Service Bulletin

DATE: JANUARY 1992

REF: JD 02/92

FIG 1

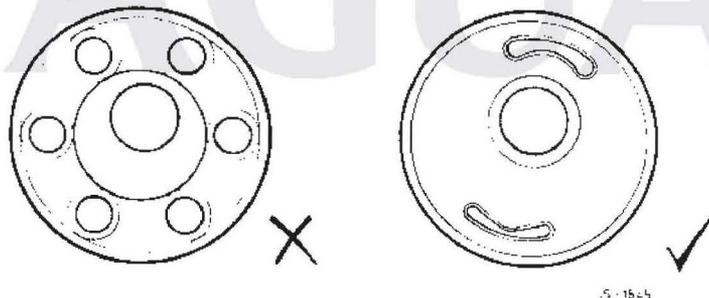
Note: The bushes originally used were termed as 'six-shooter' bushes. These have now been redesigned / replaced by the 'smiley-faced' bushes currently being used, see Fig. 1 for identification.

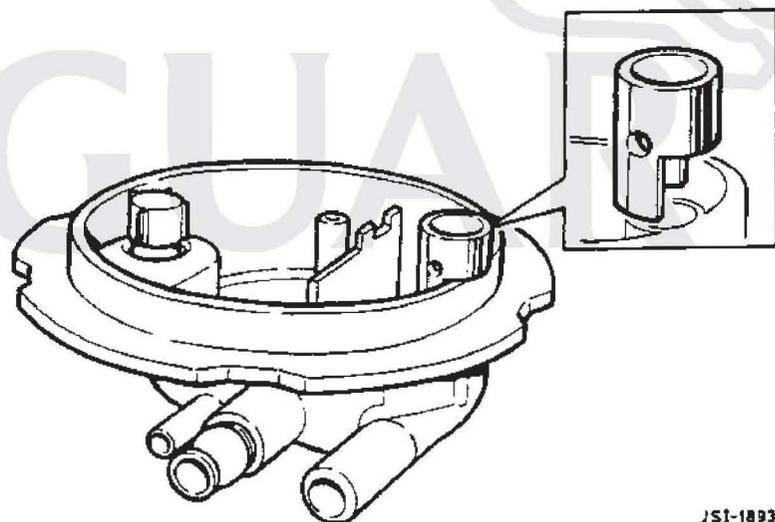
SUBJECT : REVISED FUEL FILLER NECK

ADVICE TO CUSTOMER : A revised pattern of fuel filler neck assembly may be fitted, which will allow the tank to be filled efficiently to its maximum capacity.

On Pre-Facelift vehicles up to and including VIN 179736 it is only necessary to fit a revised pattern of fuel filler neck and associated seals and gaiter.

On Facelift vehicles, commencing at VIN 179737, it is necessary to fit a breather tube extension in addition to the revised pattern of fuel filler neck and associated seals and gaiter. This involves removal and refitting of the fuel tank, and replacement of additional seals.

Assemble the filler flap to the revised pattern of filler neck, retaining the flap by driving in the new roll pin supplied.

Refit the filler neck to the vehicle, using a new "O" ring at the neck-to-tank joint, and a new gaiter between the filler neck and tank.

Fig. 1

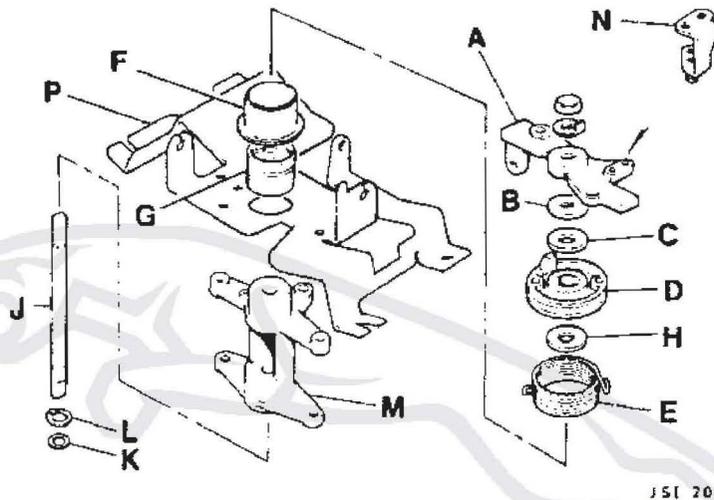
SUBJECT : REVISED THROTTLE PEDESTAL ASSEMBLY

ADVICE TO CUSTOMER : Revised components are available for the throttle linkage, as fitted on later vehicles, which will overcome the concern.

13. Assemble the components of the throttle pedestal assembly as illustrated in Fig. 1, in the following order:
 - Fit and align the nylon washer (H)
 - Fit and seat the REVISED inner torsion spring (G), (Part No. NAB 3131BA), engaging the lower lug into its locating hole in the plate and housing (P)

- Fit and align the spring separator (F)
 - Fit and align the REVISED outer torsion spring (E), (throttle return spring Part No. NAB 3131 AA) engaging the lower lug of the spring into its locating hole in the mounting plate (P)

- Fit and fully seat the REVISED throttle pulley (D), (Part No. NAB 3111AA) engaging the upper lug of the inner torsion spring to the locating hole in the lower face of the pulley

Fit the REVISED cruise control ball pin bracket (N), (Part No. NAB 3088A), refit and tighten its securing screws.
